BRUNSWICK STEAM ELECTRIC PLANT, UNIT NO. 1

BRUNSWICK STEAM ELECTRIC PLANT, UNIT NO. 2

SAFETY EVALUATION BY THE OFFICE OF NUCLEAR REACTOR REGULATION
SUPPORTING AMENDMENT NO. 6 TO FACILITY OPERATING LICENSE NO. DPR-71
AND AMENDMENT NO. 28 TO FACILITY OPERATING LICENSE NO. DPR-62
CAROLINA POWER AND LIGHT COMPANY
BRUNSWICK STEAM ELECTRIC PLANT, UNITS 1 & 2
DOCKETS NOS. 50-325 AND 50-324

NOTICE OF ISSUANCE OF AMENDMENTS TO FACILITY
OPERATING LICENSES

Figure 6.2-1

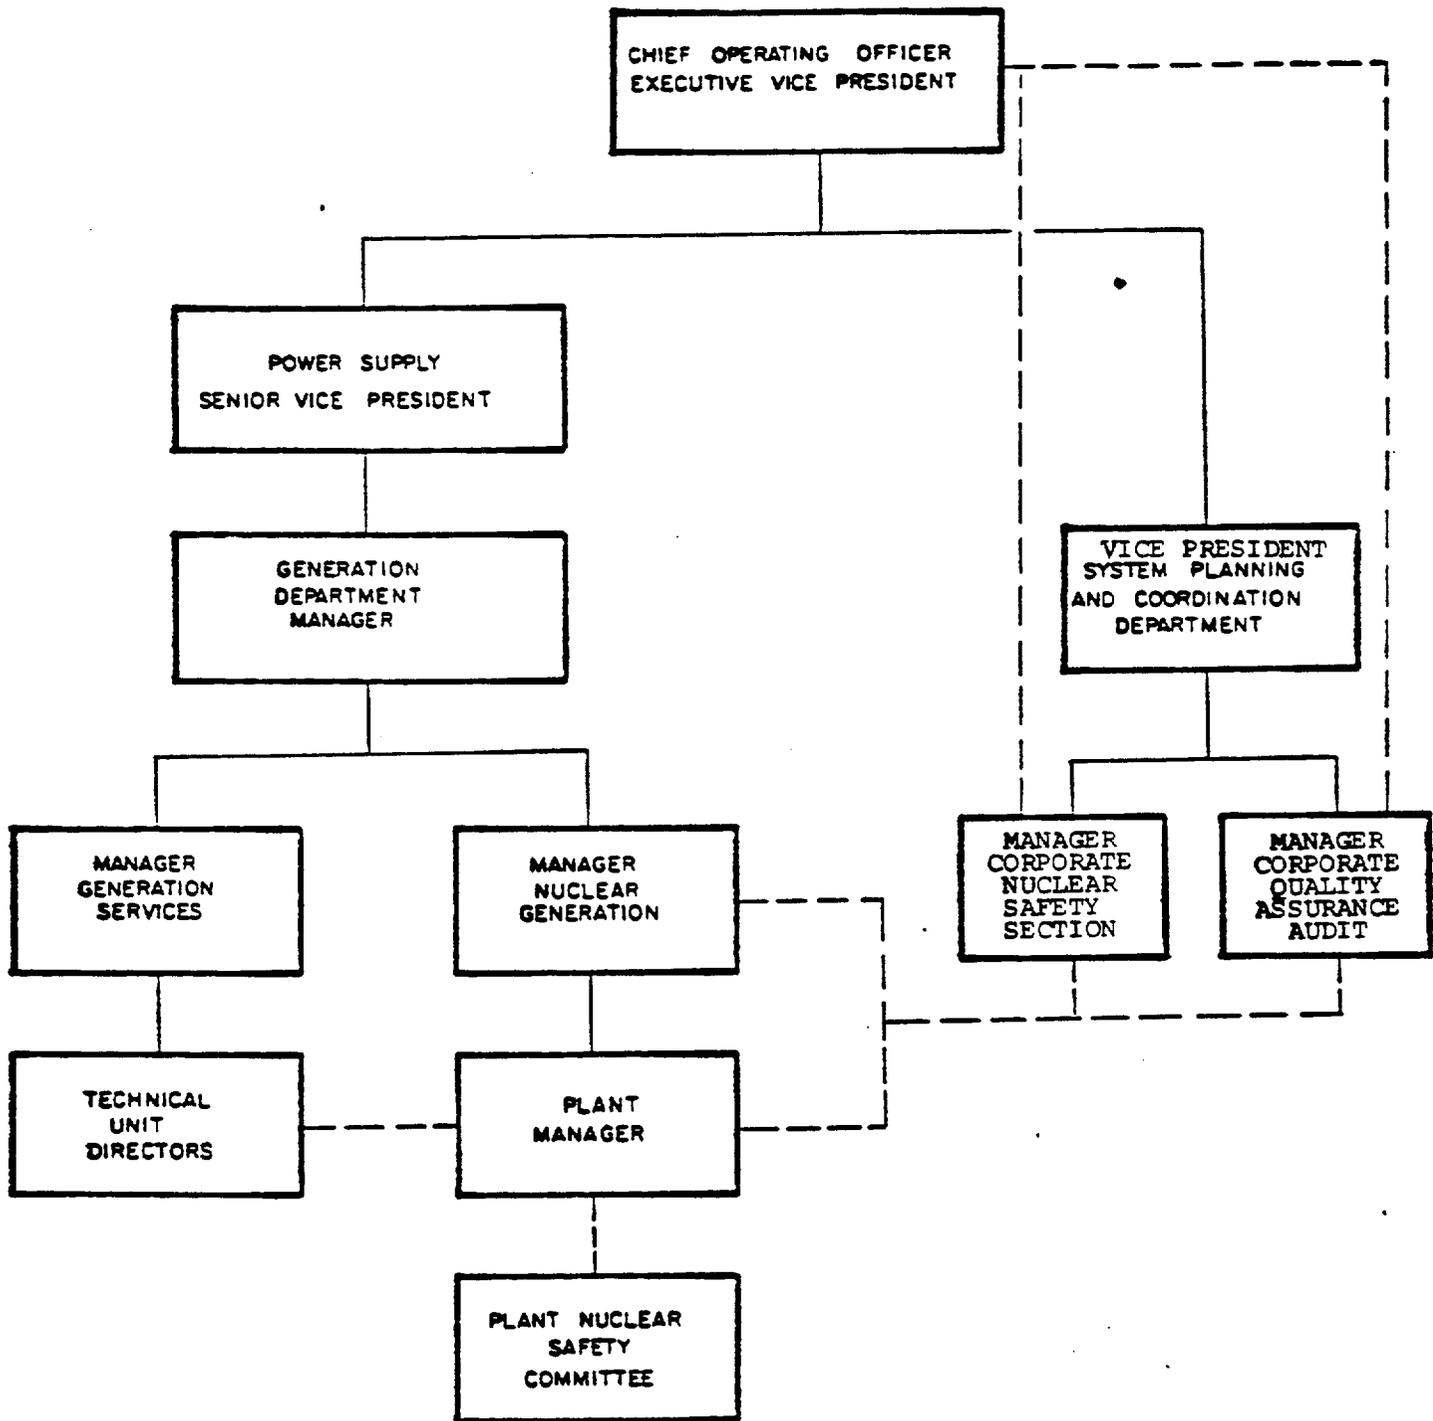
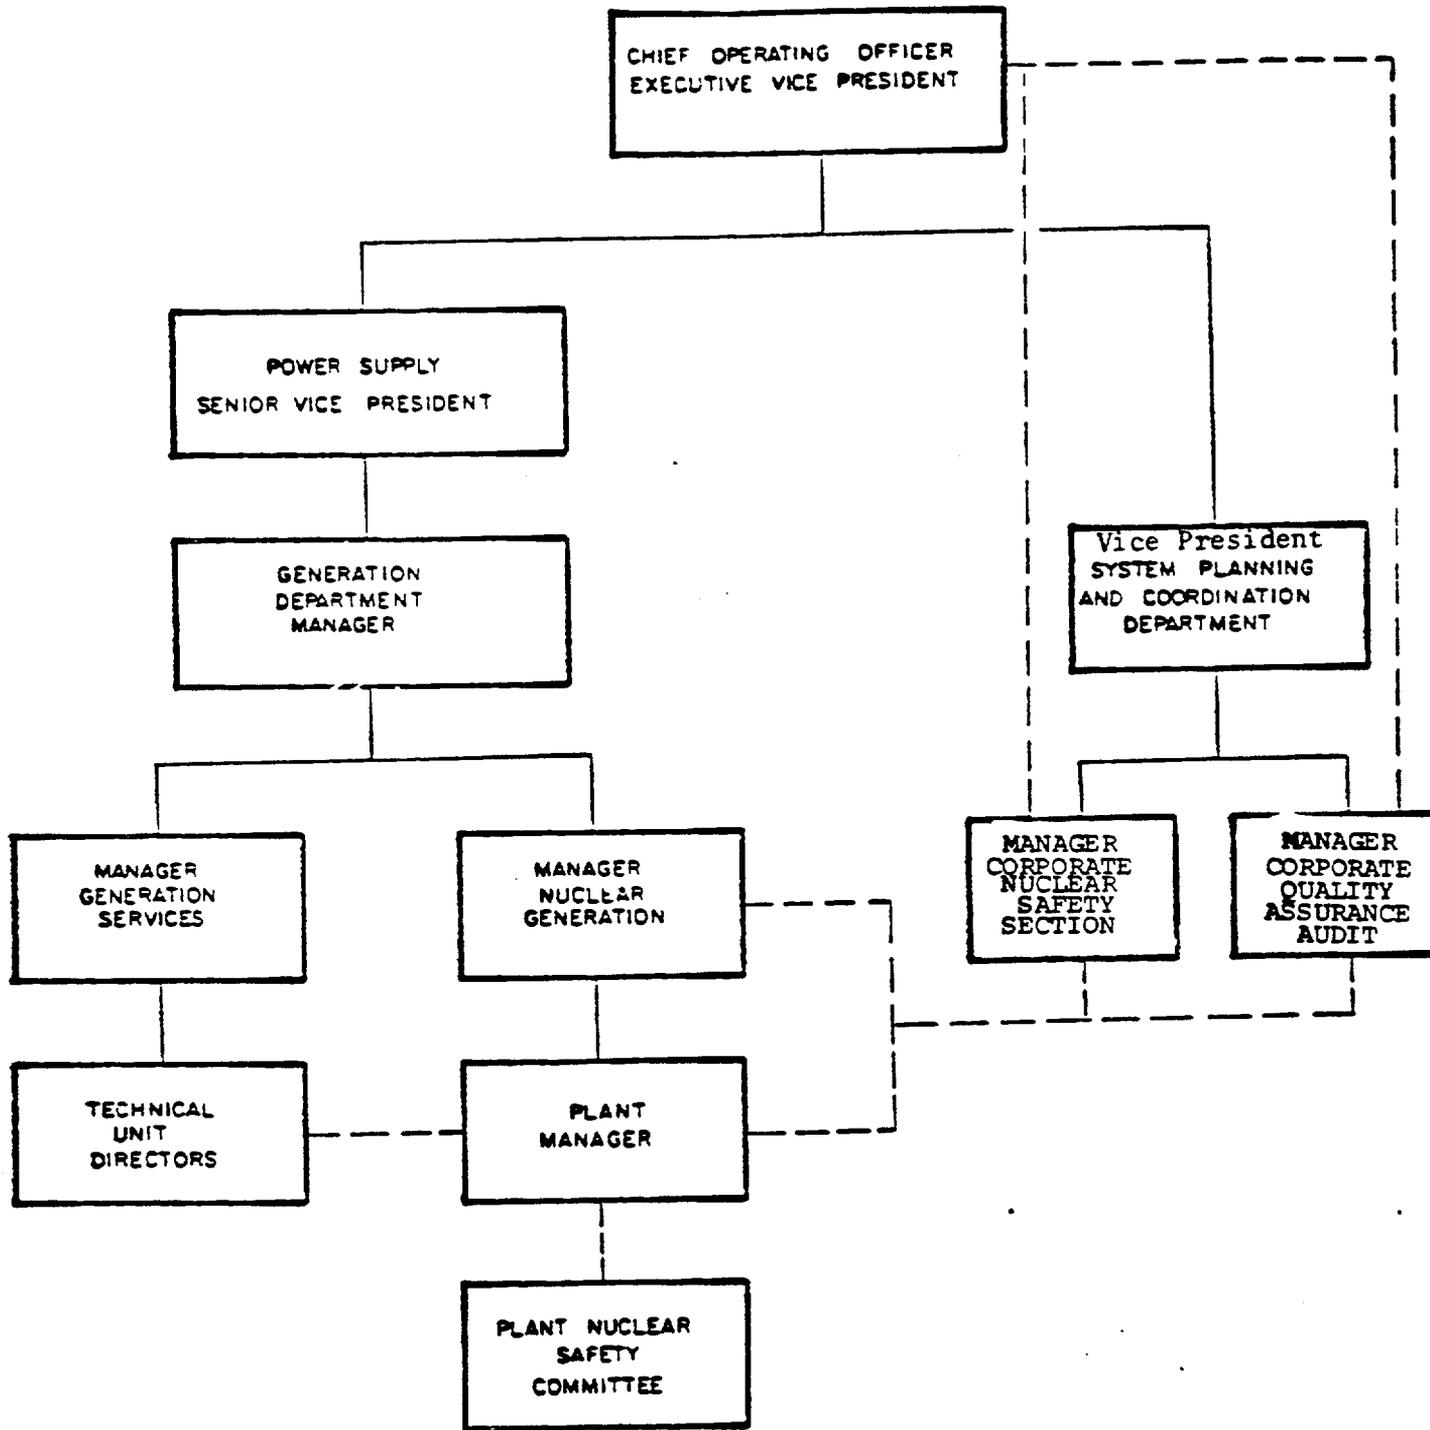
In the course of our review, we suggested the addition of position titles to some of the blocks shown on the new organization chart. This was suggested to clarify the relationship between the organization shown in the organization chart and the position titles used in the text of the technical specifications. We also suggested a minor revision in wording to clarify the meaning of "Operations Group," i.e. those organizations reporting to the Chief Operating Officer. The licensee has agreed with both of these modifications.

1. The reporting official for the Manager - Corporate Nuclear Safety Section (CNSS) and the Manager - Corporate Quality Assurance Audit Section has been changed from the Department Manager of the Technical Services Department to the Department Head - System Planning and Coordination Department.
2. Recommendations of the CNSS and audit results from the Corporate Quality Assurance Audit Section are now submitted to the Company Chief Executive Officer; Company Chief Operating Officer; Senior

Figure 5.1-1

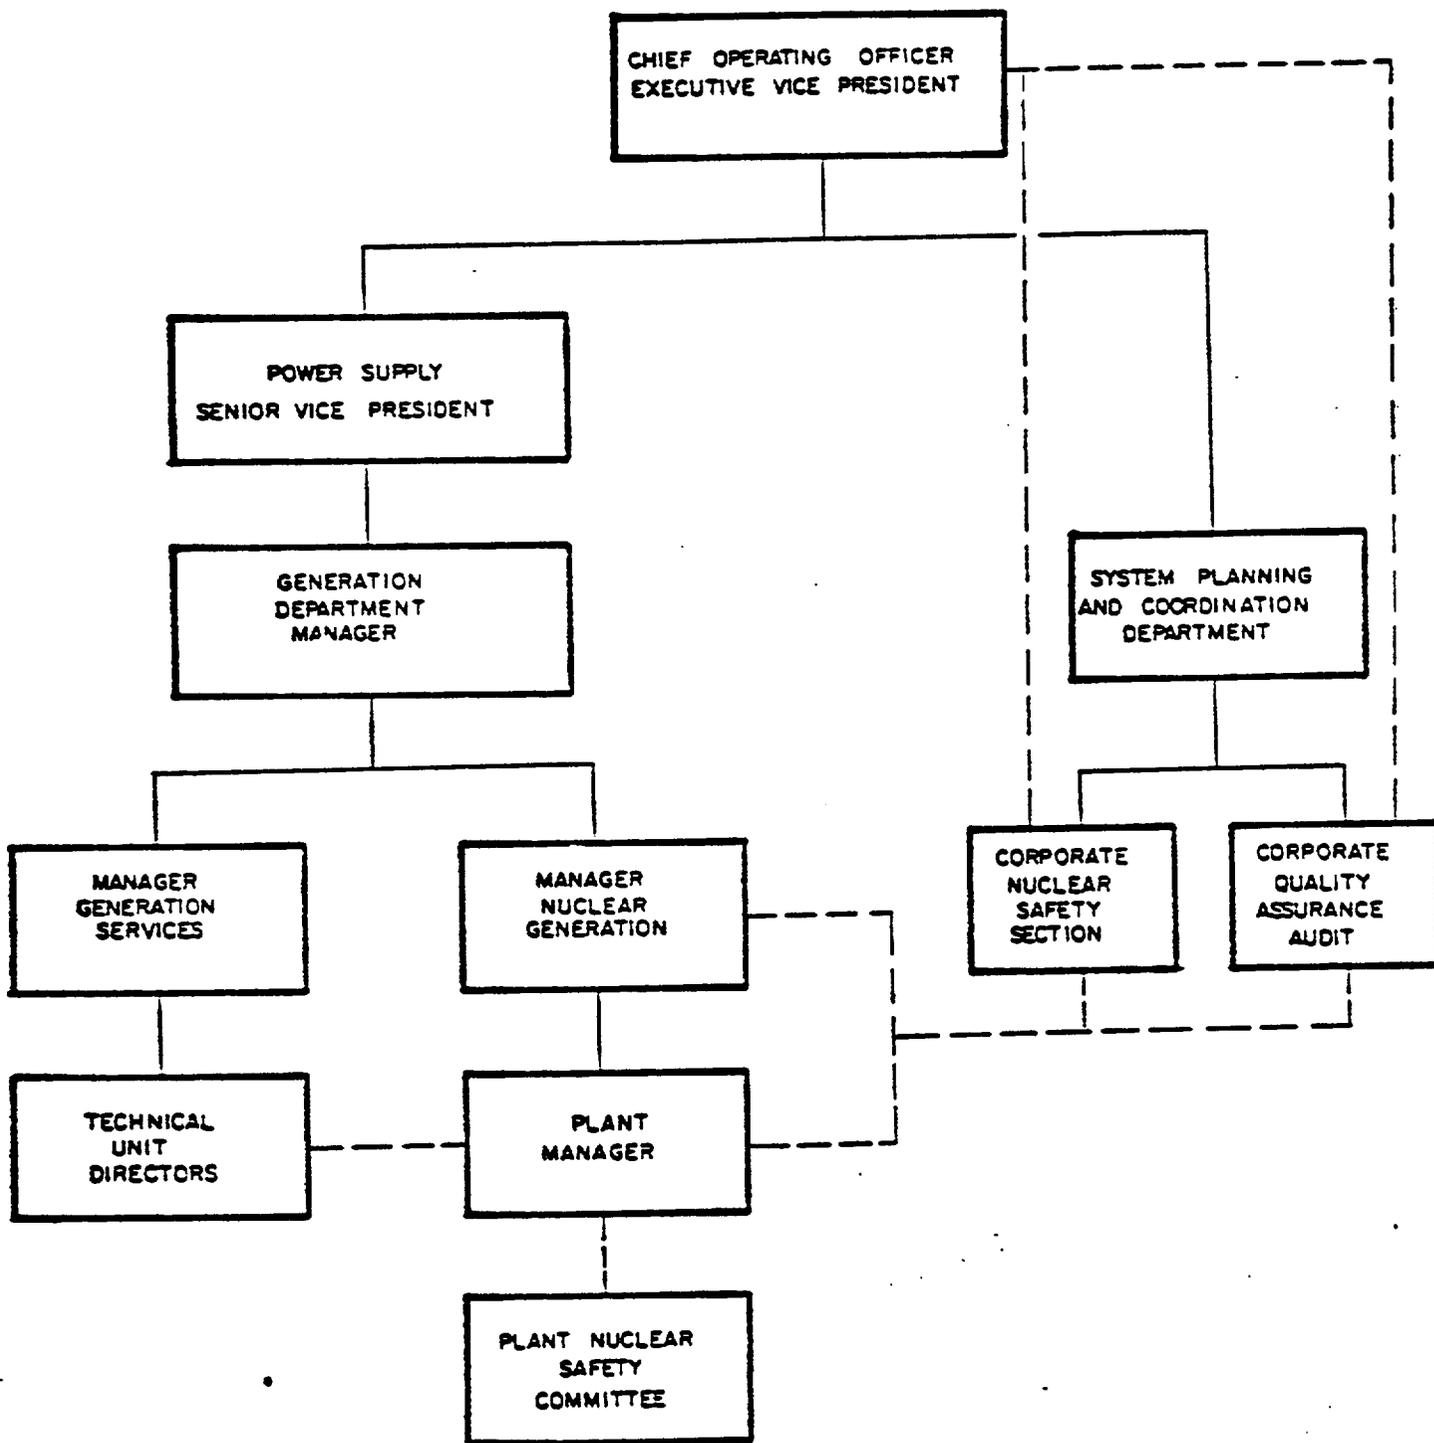
3. The title of Vice President - Bulk Power Supply has been changed to Senior Vice President - Power Supply.
4. Supplementary personnel for audit teams will be taken, when needed, from the Operations Group, instead of the Engineering, Construction and Operation Group.
5. Reports of any safety limit violations are now the responsibility of the Generation Department, instead of the Bulk Power Supply Department.
6. The Radiation Control Unit is now assigned to the Generation Services Section instead of the Nuclear Generation Section.
